A1 Birtley to Coal House

Applicant's Responses to ExA's Second Written Questions - Appendix 2.0F - Structure Options Report 2 - Allerdene Culvert

STRUCTURE OPTION REPORT 2 ALLERDENE CULVERT

Safety Engineering & Standards (SES) Record Sheet					
Scheme Name:	A1 Birtley to Coalhouse	<u>Comments Sheet Document Control</u>			
		Comment sheet version	Date HA comment sheet	Date Designer's reply sent	Notes
Document Ref	HA551462-WSP-SBR-MN001-RP-CB-0001	A	05/03/2018	16.03.2018	
		B	20/03/2018		
SOR version	Structure Option Report Allerdene Culvert	C	04/10/2018	21/11/2018 Further responses 19-02-19	
		D			
AIP Date	-	E

SCALE 1:250

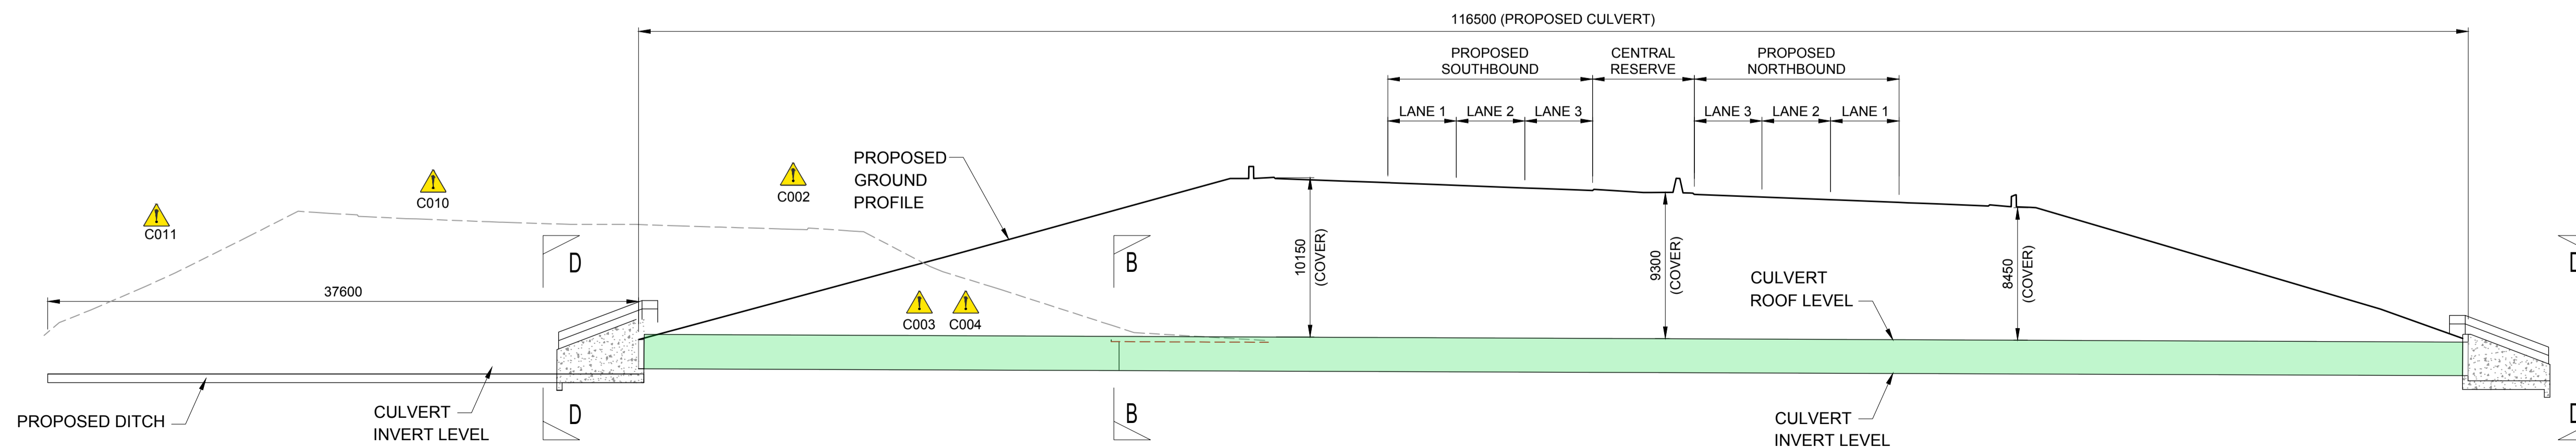
11	3.4 & 4.4.2	Please explain why preliminary proposal for Option C requires piled foundation and for option A does not? See also comment to Option C drawing – floor slab is required there that is currently missing.	<p>Piles were selected for Option C (corrugated arch) to minimise settlement of the pilecap and also sustain the horizontal thrust imposed by the arch superstructure.</p> <p>Floor slab shall be shown on the drawing for option C. 19-02-19 Reference to the requirement for a floor slab (subject to detailed design) provided on the Option C GA</p>	20/03/2018 Please see further comment to 17
		Floor slab not shown. The granular bedding material will not perform well in case of settlement or heave caused by adjacent abutment's settlement. Horizontal thrust from arch will result in laterally loaded piles i.e. large diameter required.	19-02-19 Reference to the requirement for a floor slab (subject to detailed design) provided on the Option C GA

Floor slab not shown – see further comment 11 above.	Refer to comment 11 response. 19-02-19 Reference to the requirement for a floor slab (subject to detailed design) provided on the Option C GA	
18	Designer's Risk Assessment	004 – this should be either type S or P temporary works (please state which type) and in both cases the PW Designer needs to endorse the TW design with regards to the permanent structure. Contractor appears not to be the owner here. Please consider amending.	Noted, shall be amended/reworded.	See below.
		Not amended/ reworded.	DRA shall be amended to address comment. 19-02-19 Reference to the requirement for type P and S temp work design in accordance with BD2/12 has been highlighted on the DRA	
19	Designer's Risk Assessment	005 – the weight of the structure itself is of little relevance to the overall settlement. It's rather the combined weight of the proposed embankment over the area that was not subject to surcharge load that might cause the problem, especially giving the alluvium deposits. When recommending design action (piled foundation) – was consideration given to the negative skin friction and extra load imposed onto the structure and foundation due to settlement of the	Noted, to be amended/reworded. Refer to response to comments 4 & 5.	See below.

33	4.4.2	<p>Lack of slab means piles are loaded horizontally due to thrust from the arch. Why slab is not provided as already discussed above?</p>	<p>GA drawing will be amended to show floor slab.</p> <p>19-02-19 Reference to the requirement for a floor slab (subject to detailed design) provided on the Option C GA</p>

ALLERDENE CULVERT CONSTRUCTION SEQUENCE

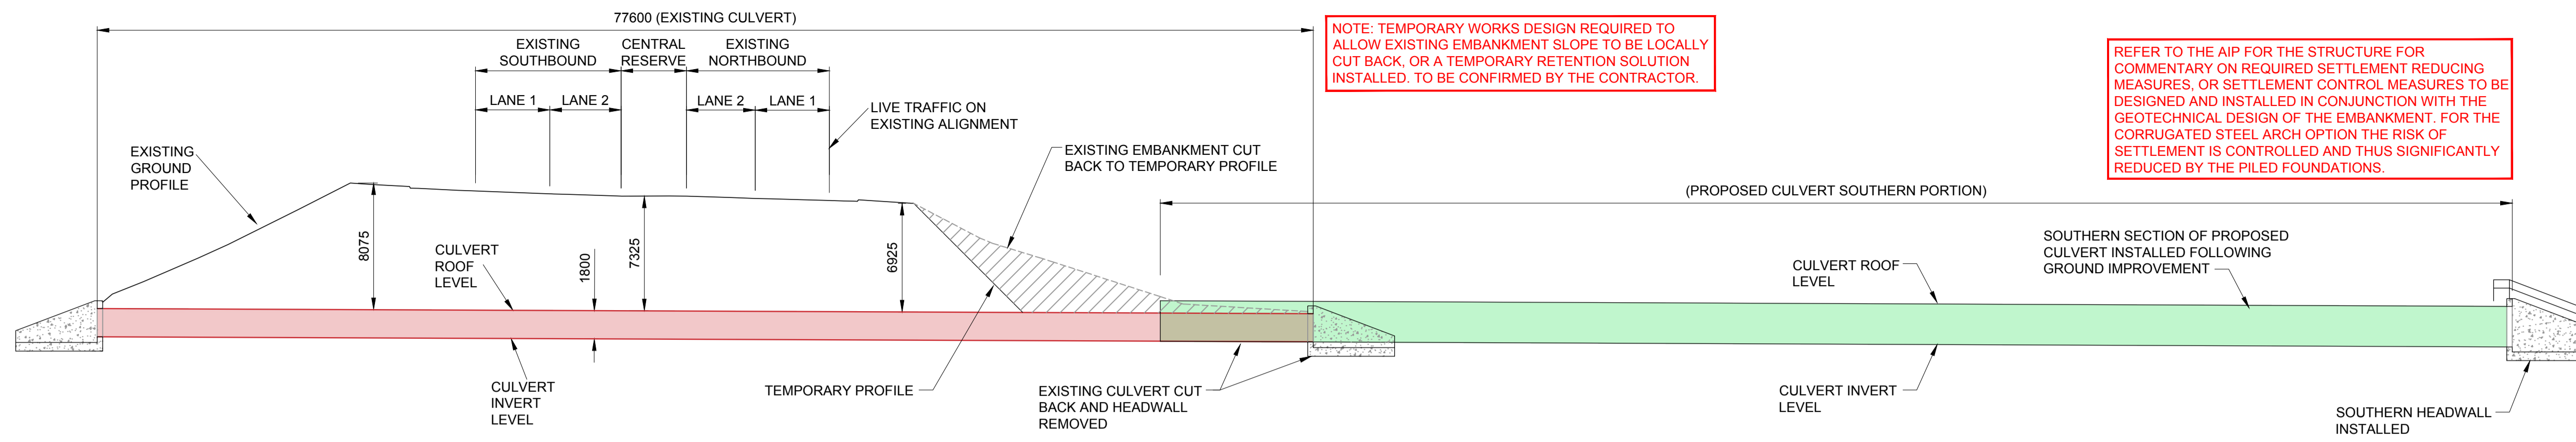
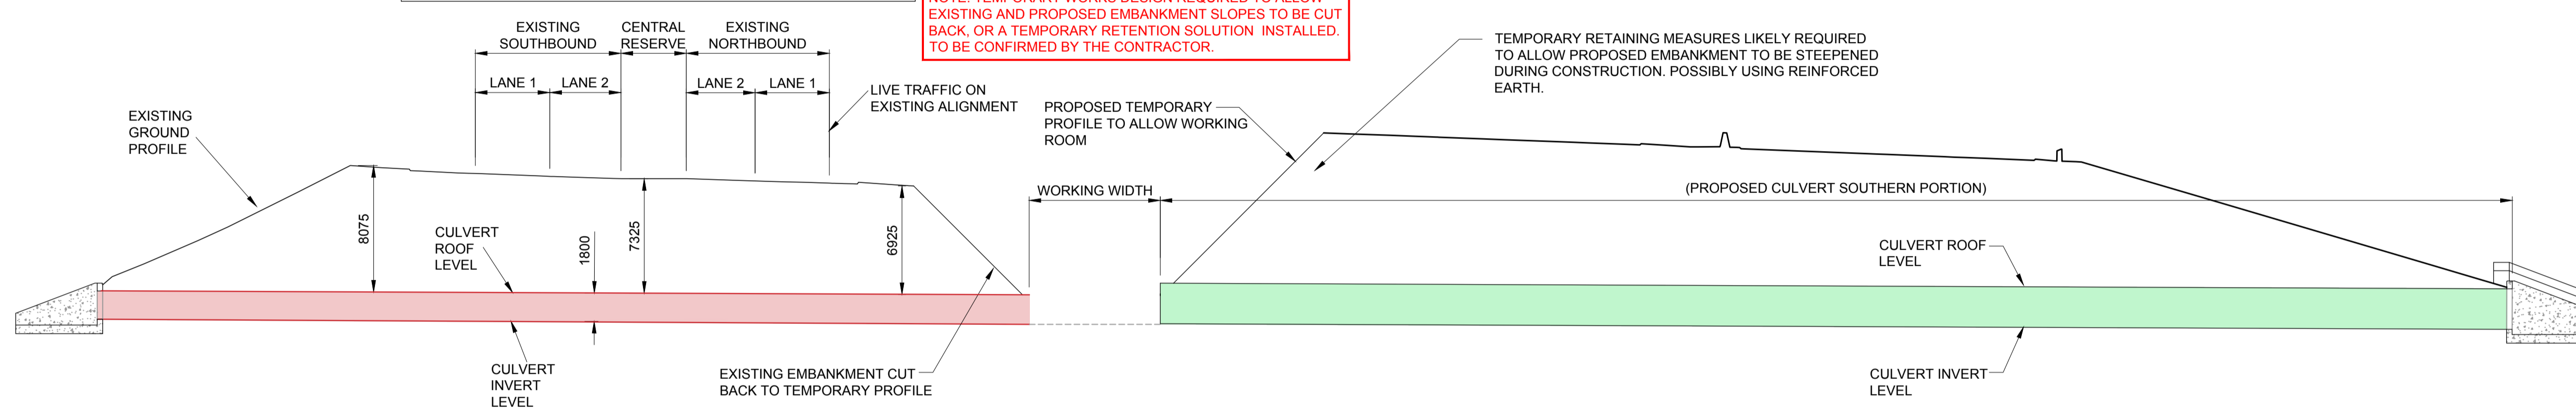
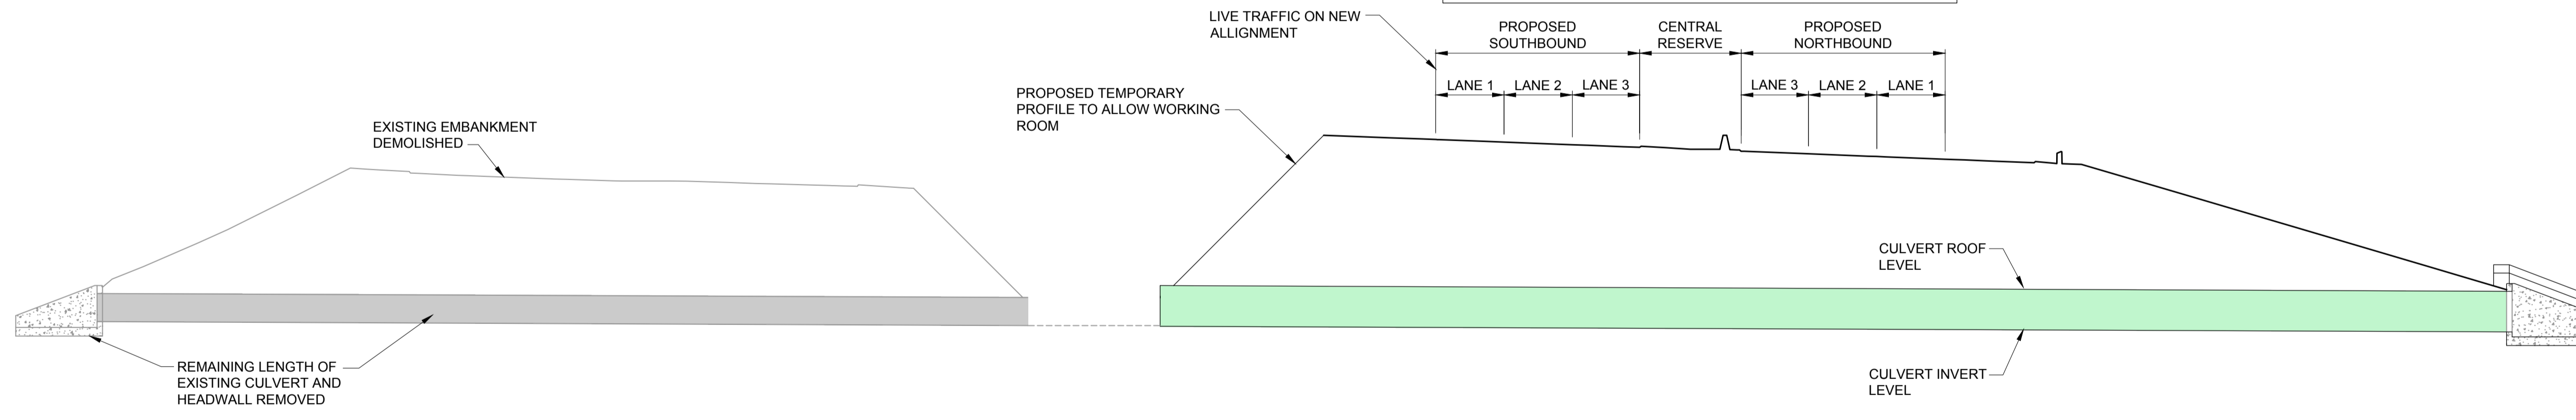
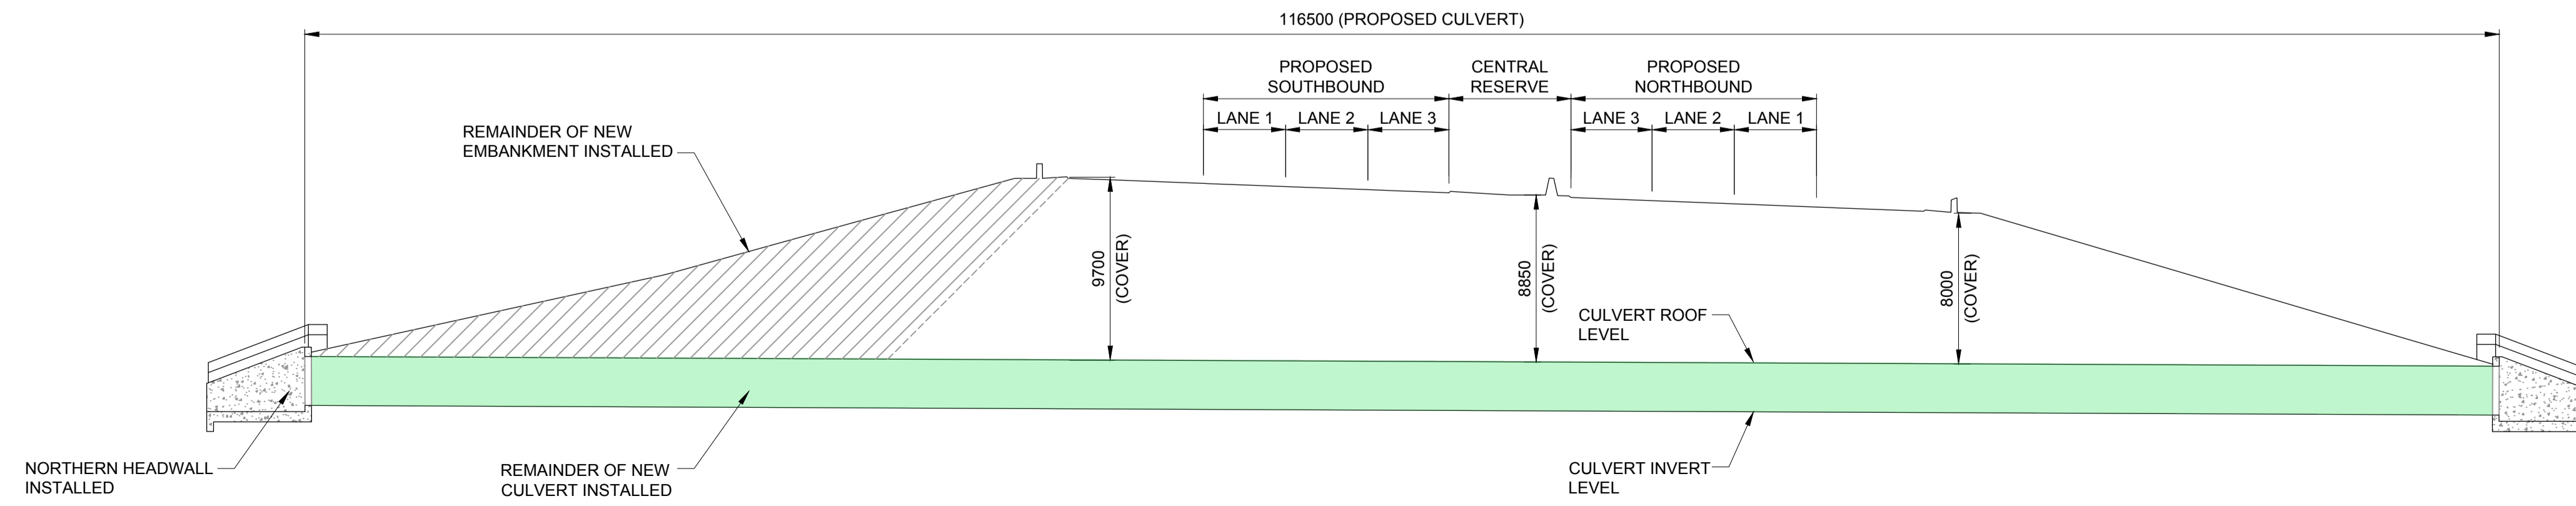
16	Appendix E	Options A-C - general Note 1 refers to bridge – is this correct?	Typo – shall be amended accordingly.	Please respond to comment below so it can be closed.
		Typo not amended.	Typo now amended.	
		Option B –construction sequence should be removed from the drawing as it's now shown separately.	Construction sequence now removed.	
		Option C – slab not shown hence piles loaded horizontally due to thrust from the arch.	Floor slab shall be shown on the drawing for option C. 19-02-19 Reference to the requirement for a floor slab (subject to detailed design) provided on the Option C GA

36	6.2.3	Please consider including information that subject to further geotechnical analysis and potential ground improvements under the embankment area, the piles in option C might become obsolete. The reduction in slope gradient from 1:3 to 1:2 (and resulting reduction in culvert length) is possible if the settlements can be controlled and reduced and that in turn is possible if either a) the assumptions about the existing ground model is overly conservative b) some remedial work to the soil beneath is proposed.	Noted and section to be updated accordingly. Refer to comment 5 response. 19-02-19 Note the comparison section of the report has been reviewed and updated to reflect the HE SES comments and SI information. The preferred option is now Option B – Corrugated Pipe with ground improvement to the wider embankment	
37	Construction sequence	Step g&o – this refers to corrugated steel pipe unit but it should be generic. Please amend. Step j - water allowed through the culvert before new section to the north is reconstructed – is this correct? Step l - should this not be after step ‘m’? Last step should be to backfill to achieve the ‘in service embankment profile (from reduced to the north face).	Construction sequence to be updated to address comments. 19-02-19 Construction sequence has been amended to align with the comments
